AL WATHBA
WATER TREATMENT PLANT
BAGHDAD, IRAQ

SIGIR PA-05-002
MARCH 15, 2006

Al Wathba Water Treatment Plant in Baghdad, Iraq

Site Photo 10: Filter building, interrupted concrete pour, dated 31 May 2005
(Provided by the Government QAR)

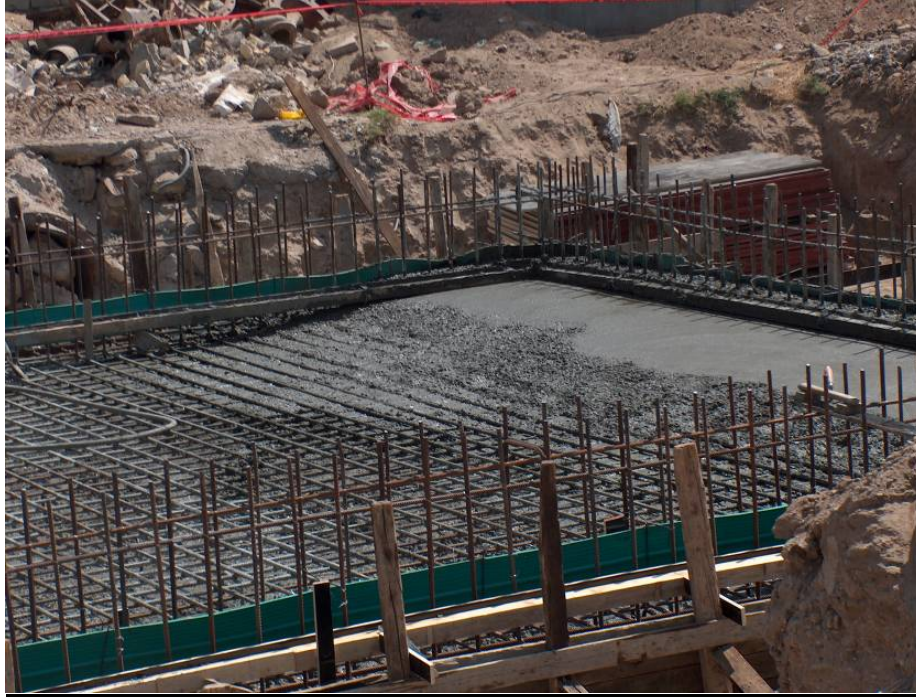
There are concerns regarding the quality of the interior concrete pad of the wet well section. Review of the QA documentation and discussions with the Government QAR identified problems during the placement of the concrete in the wet well section. This concrete pour on 31 May 2005 was interrupted due to equipment failure and the concrete setting before the pour could continue (Site Photo 10, which was provided by the Government QAR). This interruption could cause bonding problems between the old and new concrete, which would decrease the strength of the concrete.

The contractor said he followed the procedures in contract specification “FA 000 215 033000: Specification for cast-in-place concrete,” which calls for the use of a bonding agent between the old and new concrete. The Government QAR said the contractor did not use a bonding agent or follow specification FA 000 215 033000. A copy of the contractor construction deficiency log and daily quality control reports were requested to determine actual events, but they had not yet been provided at the time of this report.

The contractor recommended taking core samples and testing to determine if the floor is within specifications. Relying on the Government QA reports and in the absence of information to the contrary, it would be prudent to obtain a core sample to determine if the concrete is within specifications.
